DESIGN ADVISORY BOARD Wednesday November 9, 2016 at 3:00 PM Conference Room 12, City Hall, Burlington, VT Agenda

MEMORANDUM

To: The Design Advisory Board
From: Mary O'Neil, AICP, Principal Planner
RE: ZP17-0479CA
Date: November 9, 2016

File: ZP17-0479CA
Location: 79 Lakeside Avenue
Zone: RL-W **Ward:** 5S
Date application accepted: October 12, 2016
Revised plans received (version 3): October 27, 2016
Applicant/ Owner: Rebecca Schwarz
Request: Expand 2nd floor of existing single family home.

Lower Floor Plan

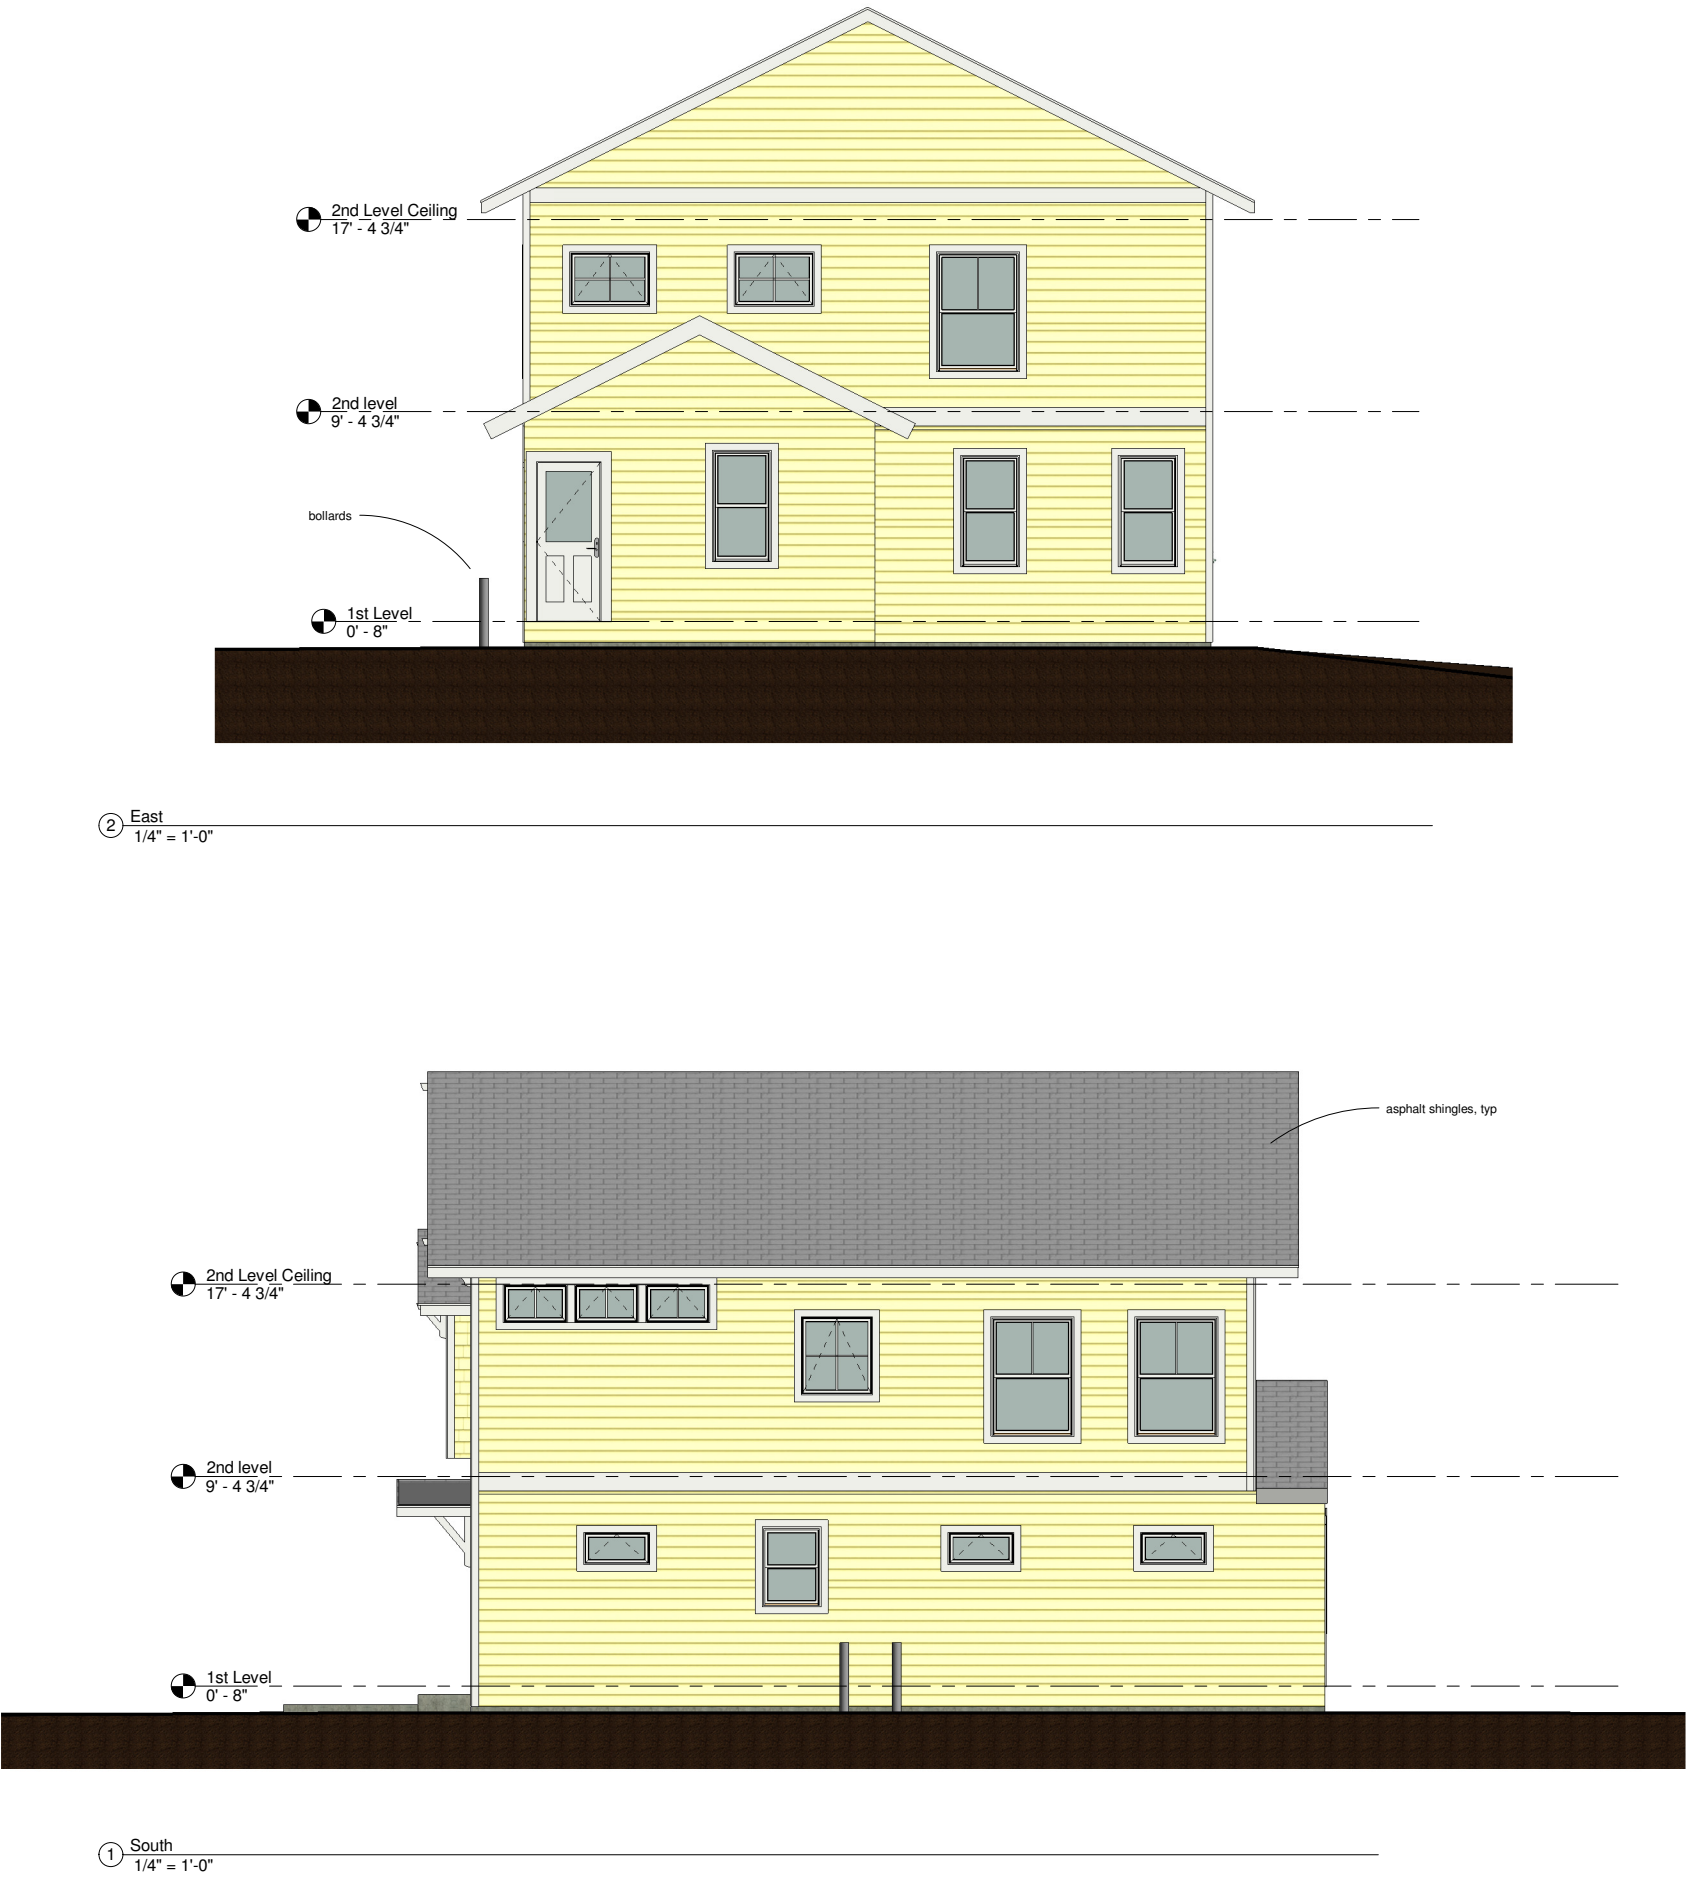
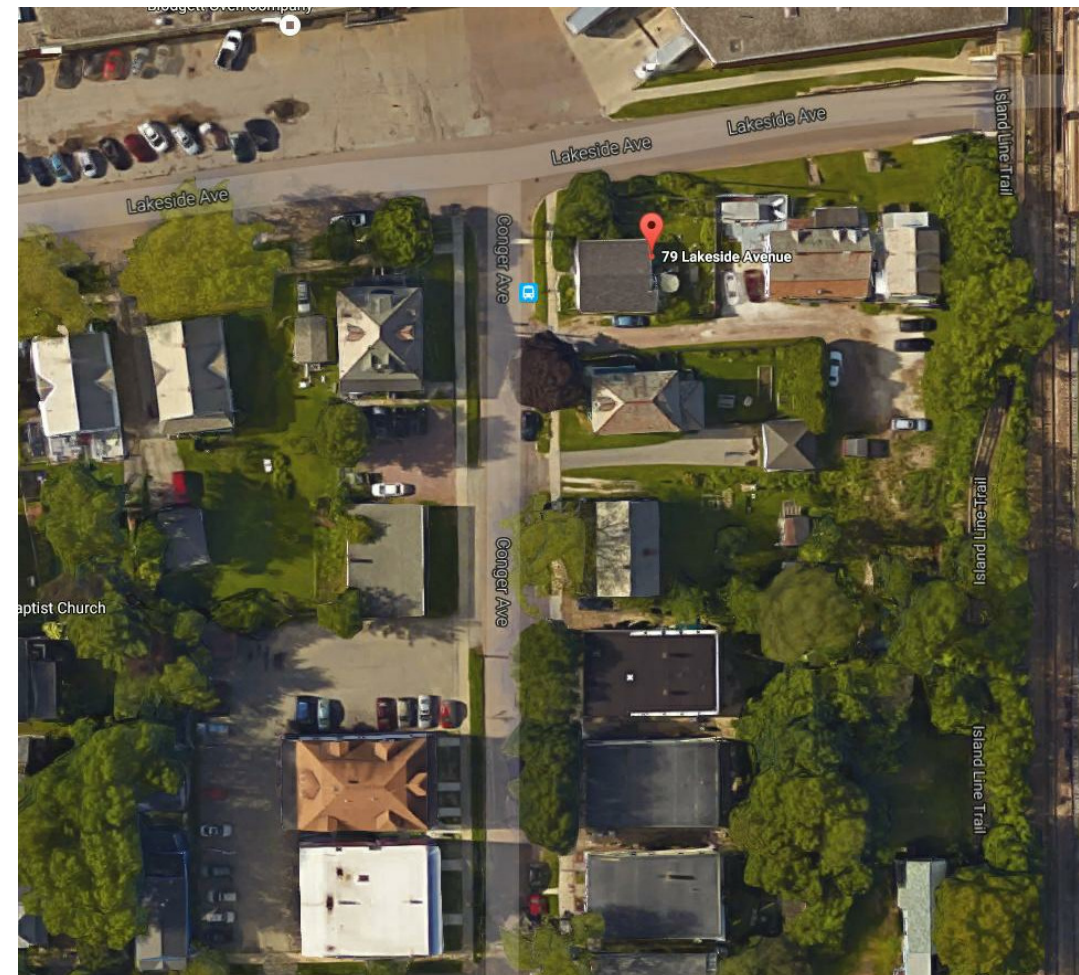
There is inconsistent arrangement with windows; the second floor south places transom style windows above or within a closet; their size and location under an eave line will not likely provide much light. A similar window is proposed on the north, 2nd floor.

While a more rhythmic arrangement would be preferred, the internal use is dictating window size and location.

Motion by: Steve Offenhartz: I recommend approval, with the following revisions to building elevations: The North elevation awning window should match the others, and change triple awning window on the south elevation to a lower sash matching window head height of other windows.

PROPOSED SITE PLAN
CHABAD OF VERMONT
57 SOUTH WILLIAMS STREET
BURLINGTON, VT 05401

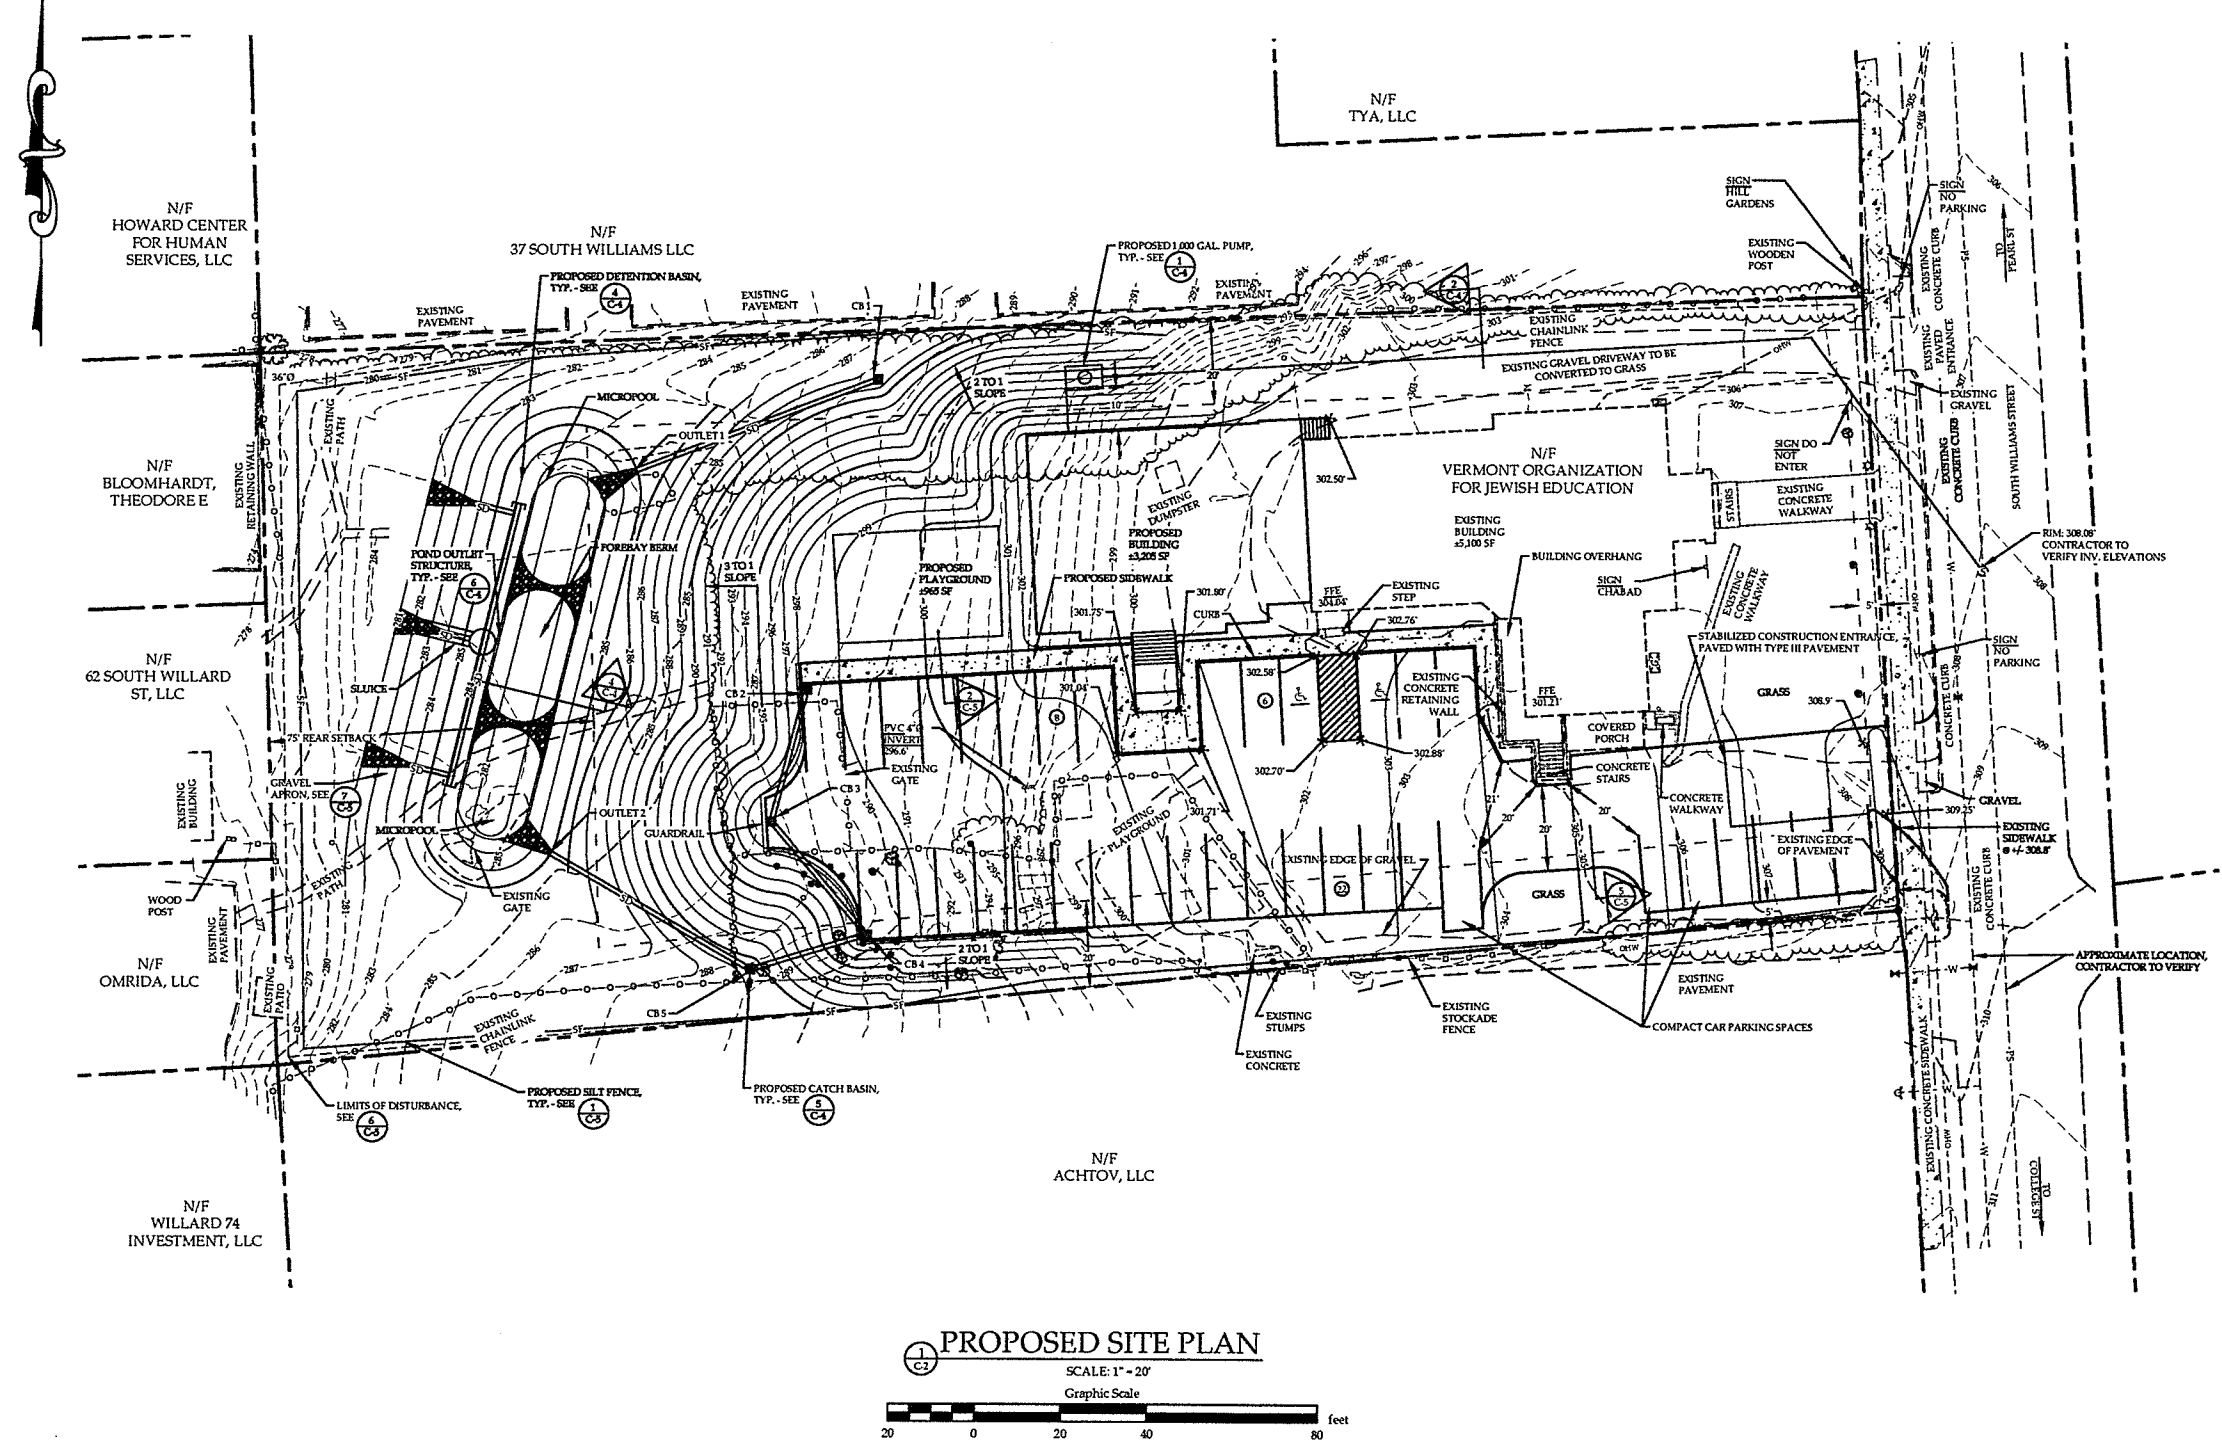
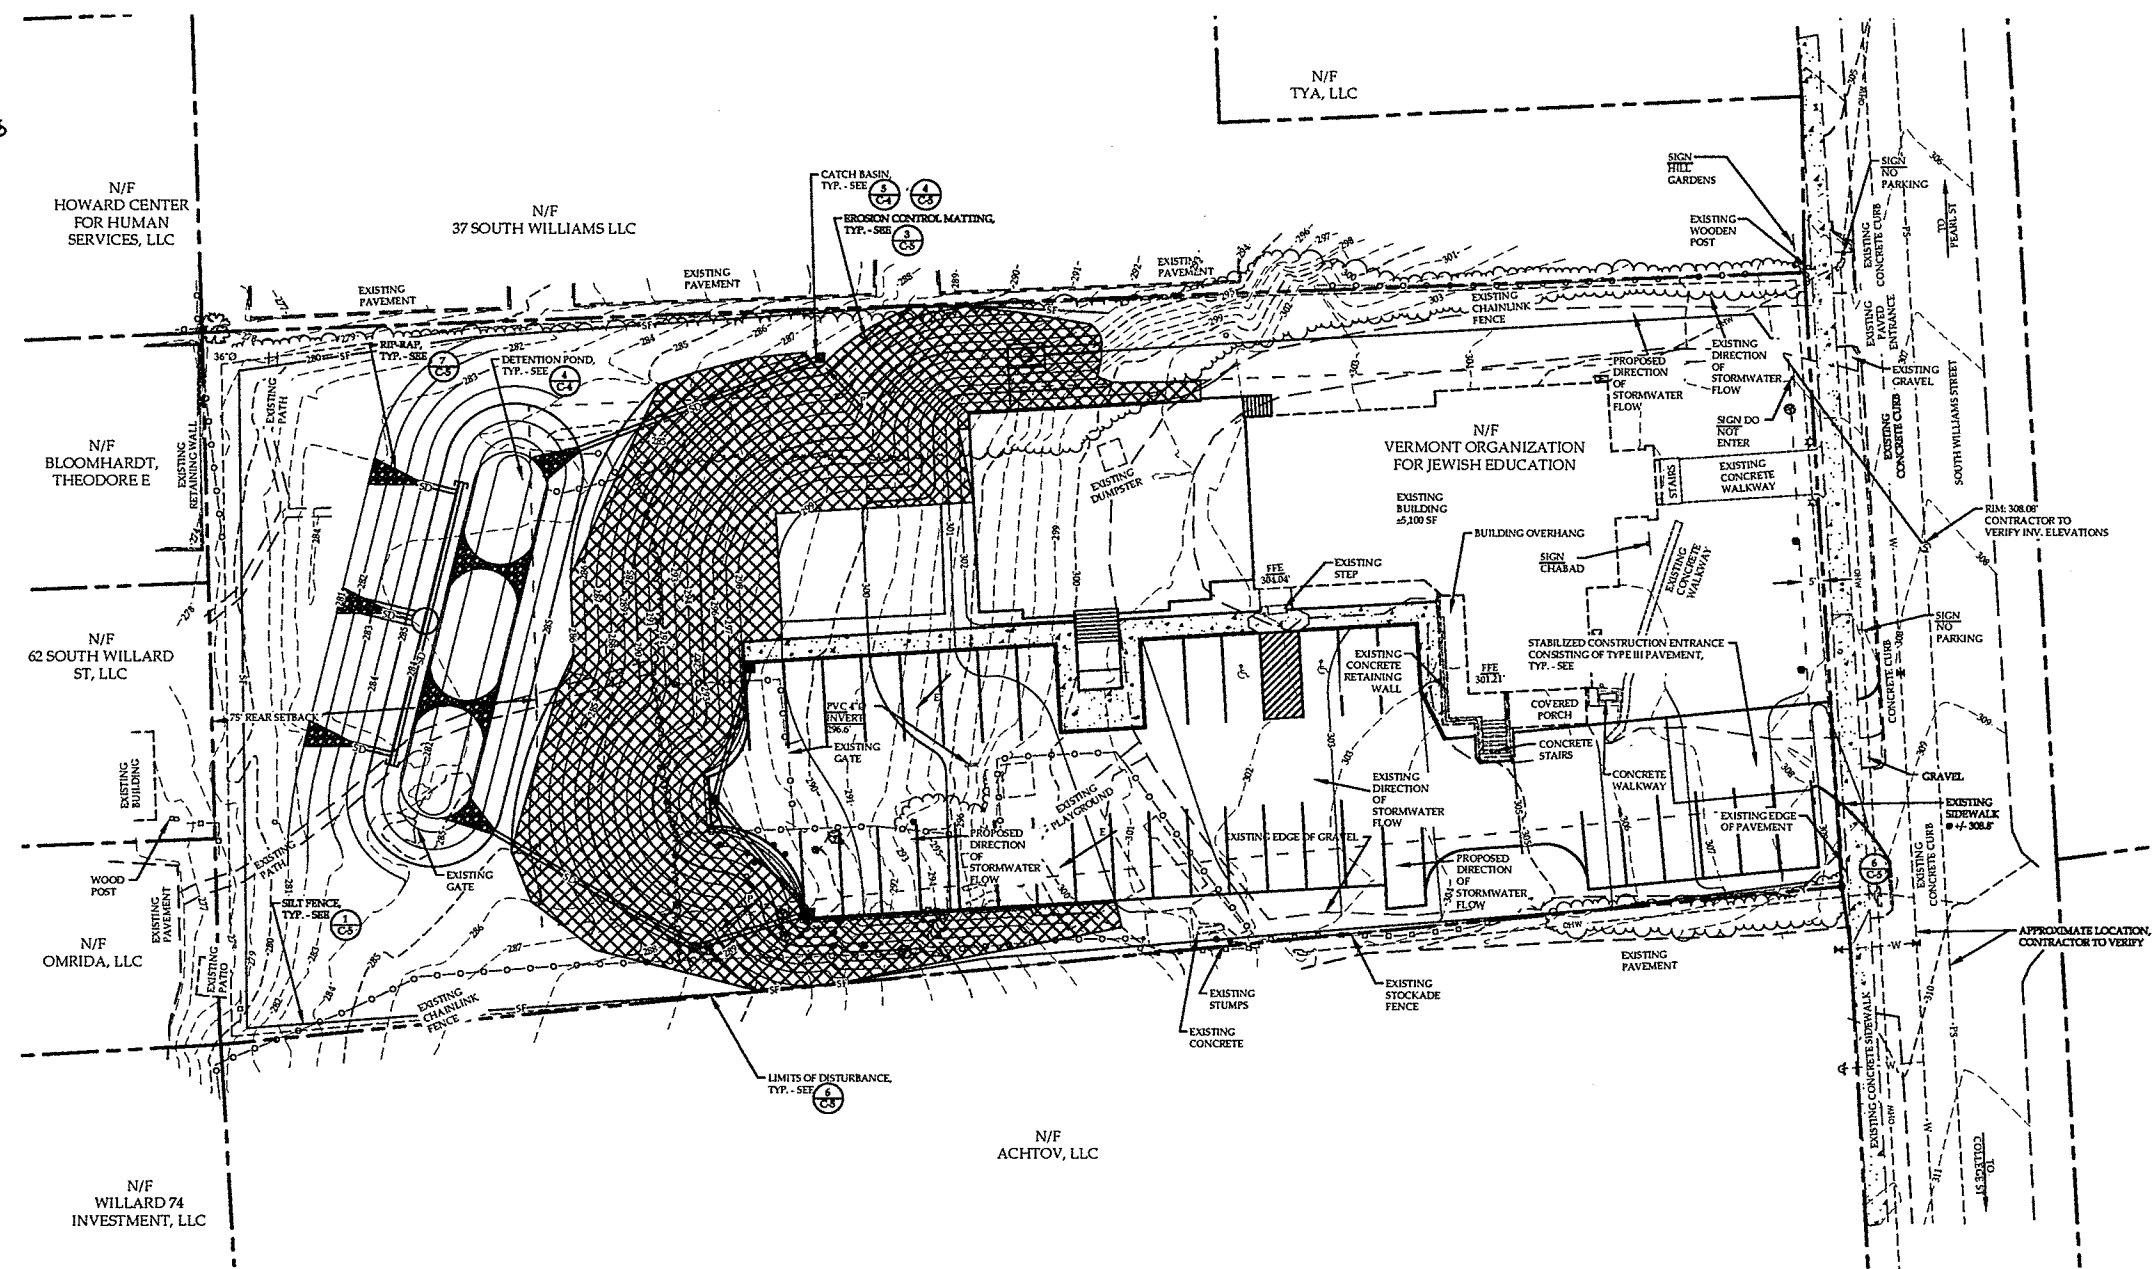
The proposed parking area depicts handicap parking spaces and all building entries appear to be accessible at grade. The proposal also includes direct access to the internal elevator. A curb cut providing ADA access between the parking area and the elevated walkway is not identified on the plan and needs to be.

The proposal includes 25 new exposed surface parking spaces. Surface parking areas of 15 or more spaces require at least 1 shade tree for every 5 parking spaces. The landscape plan shows 3 shade trees along the south property line, 3 shade trees at the rear of the parking area, and 2 shade trees between the new parking spaces closest to the building addition and the proposed playground location. The shade trees must be 2.5" – 3" caliper at planting with an expected mature canopy of at least 25' diameter. At least 30% of the surface parking should be shaded. No shading analysis has been provided and must be.

The project plans do not include indoor or outdoor bike parking spaces. Additional details relative to type and number of bike parking spaces are needed.

All new utility lines must be buried. A heat-pump system is proposed that will have an outdoor mechanical unit. The location of this unit, as well as any other mechanical units, must be identified on the site plan. Mitigating and screening measures must be taken to minimize auditory and visual impacts from the public street and adjacent properties. A screened trash and recycling enclosure(s) will have to be included on the site plan as well. The dumpster must be set on a concrete pad.

The project plans do not depict mechanical unit locations. The submittal includes spec sheets for a heat pump. Heat pump mechanical units are typically located outside. The applicant must locate the unit in a location and manner that both mitigates and screens its auditory and visual impact from neighboring properties and the public street. All new utility lines will have to be buried.

1. The site plan shall be revised to include:
 - a. All required parking spaces;
 - b. All required bicycle parking spaces;
 - c. The location of the garbage/recycling area. Any dumpsters must be placed on a concrete pad;
 - d. A curb cut on the walkway along the south side of the addition to accommodate ADA accessibility; and
 - e. The location of the heat pump mechanical unit, and associated mitigation/screening.
2. The curb cut for the exit drive to the north of the building shall be removed.

3. A shading analysis for the surface parking shall be submitted.
4. Entry lighting levels shall be included with the photometric plan.

Motion by: Matt Bushey: I recommend approval of the project as presented, with the requirement that the mechanical unit on the north side of the addition be indicated on the site plan, and that it be adequately screened with existing or proposed landscaping or
